Cause of Fault in Power Distributor (in front left wire harness): Rework Required (21/14)

Model Line: **Panamera**

Model Year: **As of 2010 up to 2013**

Concerns: **Power distributor**

Figure 1

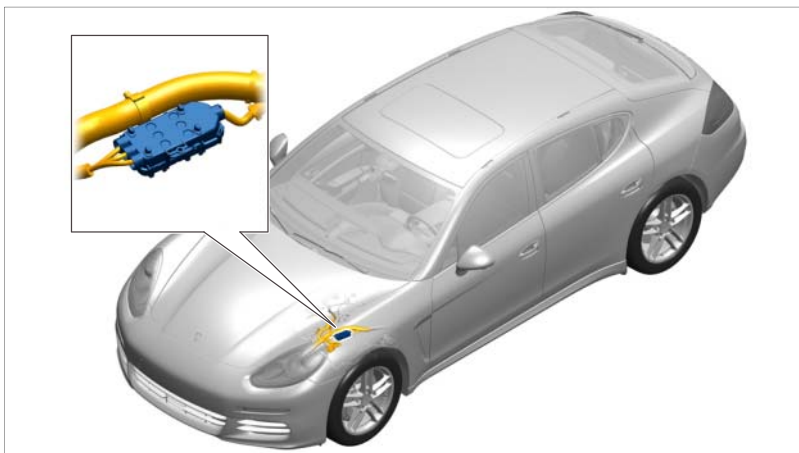
Information: **In the event of complaints relating to the overall power supply on the vehicle and if "Connections in power distributor corroded" is discovered as the cause of the fault, the cover on the power distributor (⇒ Figure 1) must be sealed using new sealant.**

Action Required: Clean corroded parts of the power distributor and seal the sealing face for the power distributor cover with "Union cement" sealant.

Figure 2

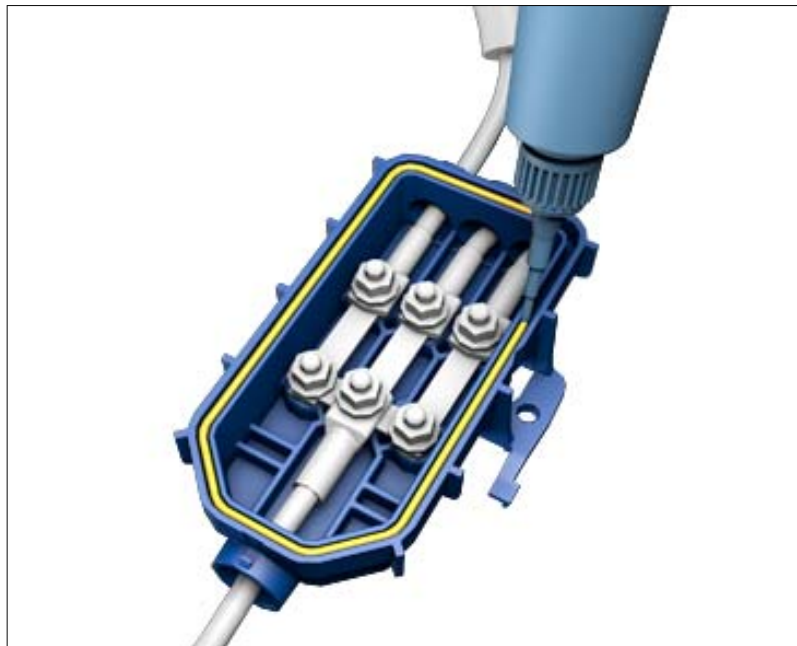
- 10 Using the tube, apply a thin, but consistent bead of Union cement sealing adhesive over the entire sealing face (⇒ *Figure 2*).
